Subject ▶ Change on foot and foot receiver

For Models ▶ 9036 and M924

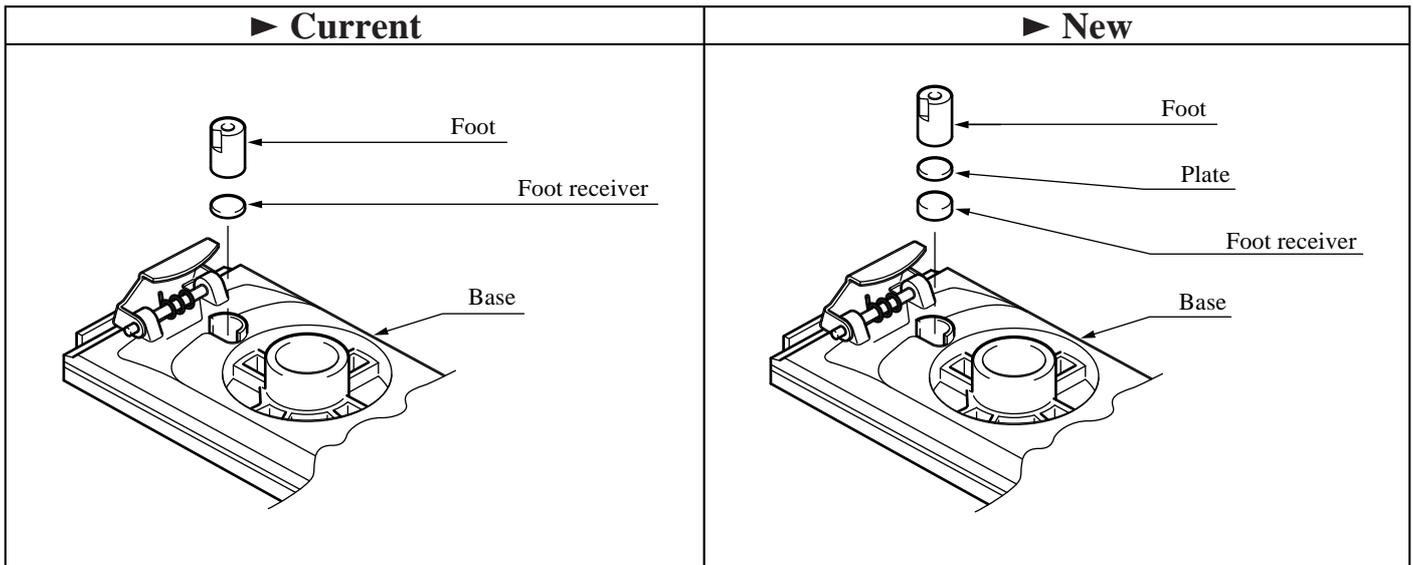
- * The feet will be changed from 25 mm (1") to 23 mm (29/32") in length.
- * Two plates will be added.
- * The foot receivers will be changed in thickness and material.

▶ Current	▶ New
Thickness	2 mm (3/32")	3 mm (1/8")

Item No.	Current part		Q'ty	I/C	New part		Q'ty	Note
16	Foot 421339-2		2	No	Foot 421538-6		2	Interchangeable as a set
15					Plate 343650-1		2	
30	Foot receiver 162145-3		2	No	Foot receiver 421539-4		2
